**REPUBLIC AVIATION CORPORATION  
FARMINGDALE, LONG ISLAND, NEW YORK  
SERVICE DEPARTMENT**

**MANDATORY CHANGE**

SERVICE BULLETIN NO. 1

MODIFICATION FIREWALL TERMINAL BLOCK

FIGURE 1

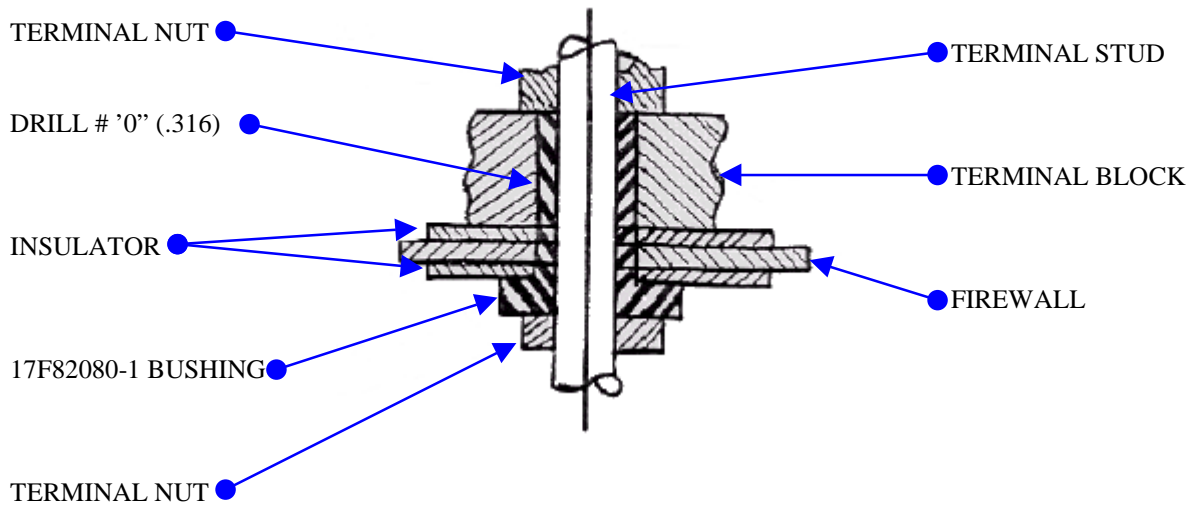
Reason for Change: To prevent short circuiting of terminal studs on the firewall.

This change involves removing each stud from the terminal block on the firewall, enlarging the stud holes, installing a bushing and reinstalling the stud and shall be accomplished as follows:

1. Open top engine cowl and remove right hand side cowl.
2. Disconnect wires from one terminal and remove stud.
3. Open up existing hole by drilling through with No. "0" (.316) drill.
4. Insert 17F82080-1 Bushing from bottom side. Refer to Fig. 1.
5. Reinstall terminal stud and reconnect wires, omitting the AN960-10 washer.
6. Repeat the above process for all seven terminal studs.
7. Replace cowling.
8. Check electrical circuits for operation and make suitable entry in airplane log book.
